## ADDENDUM NO. 4

December 8, 2017

Appoquinimink School District

Whitehall Elementary School – Bid Package 'A'

Bollard, Model R-8464-RA

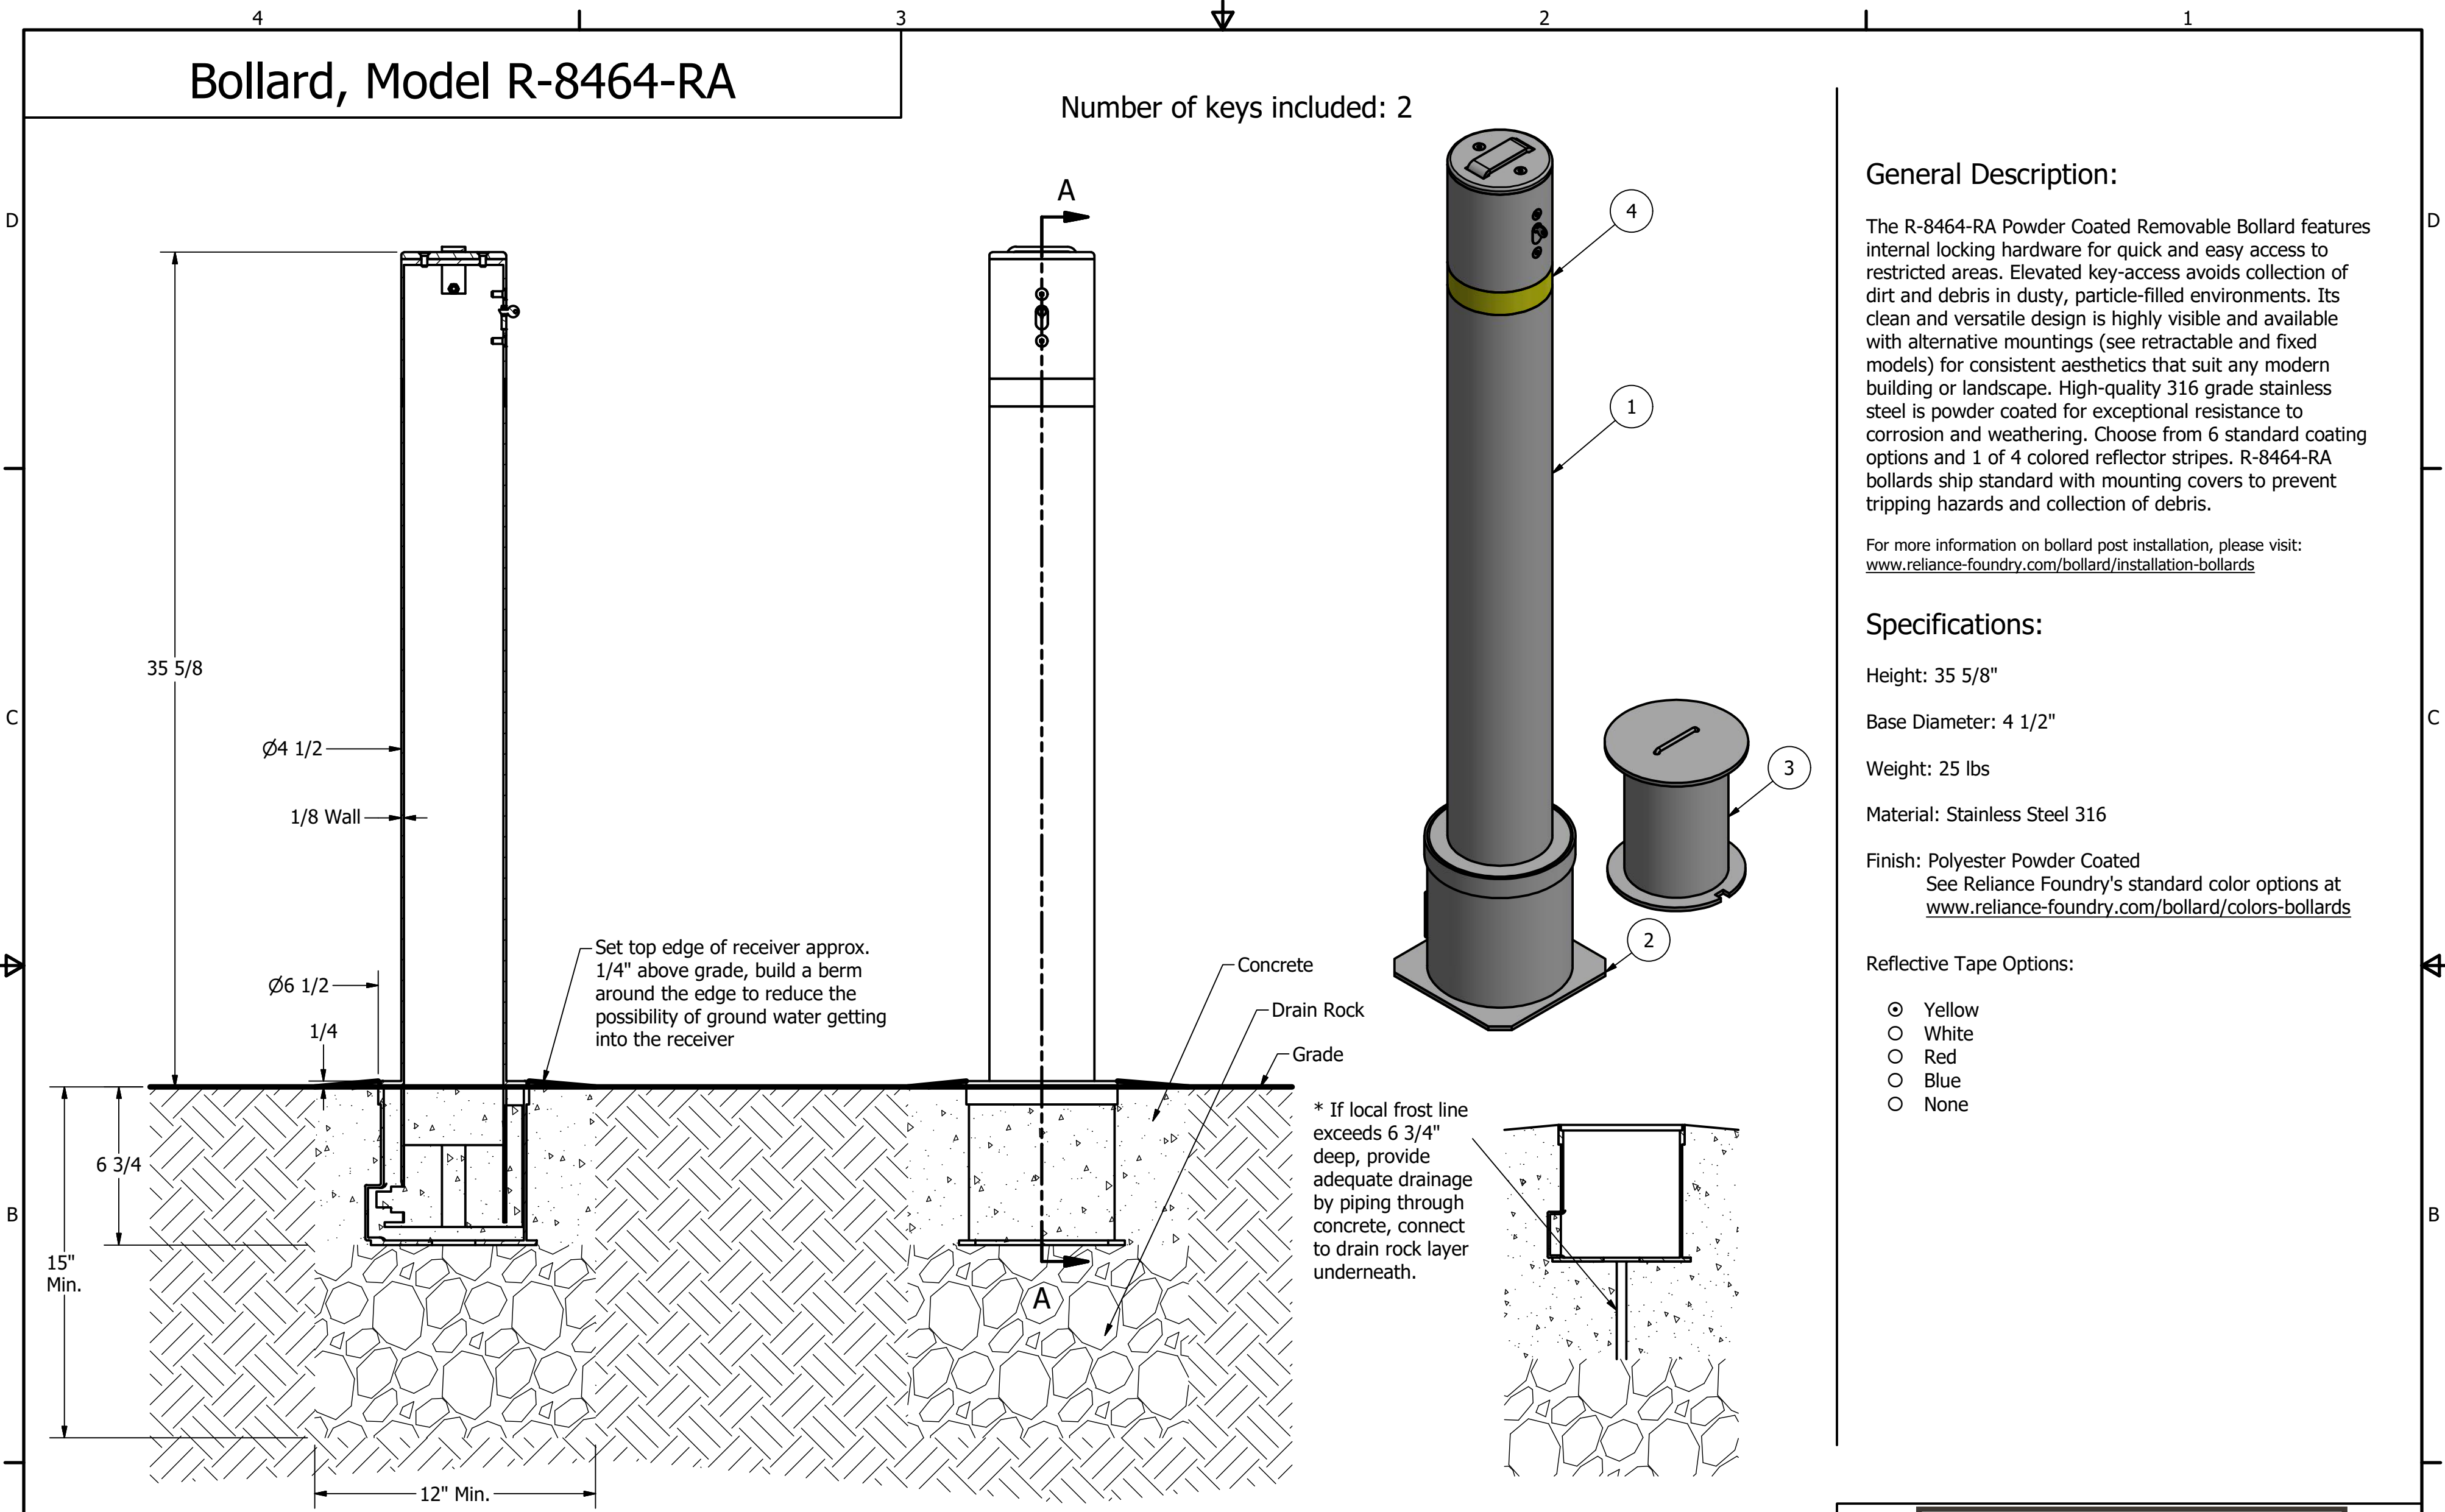
2. What type of material is the roof drain piping, HDPE, SCH40 PVC, or SDR35?
  3. Can removable bollard model # Model R-8464-RA by Reliance Foundry be approved for use? A cut sheet is attached.

- 2.) Schedule 40 PVC as specified.
- 3.) Products similar in size, material, quality and functionality may be considered by the owner at the time of product submittals. See attached product data sheet.
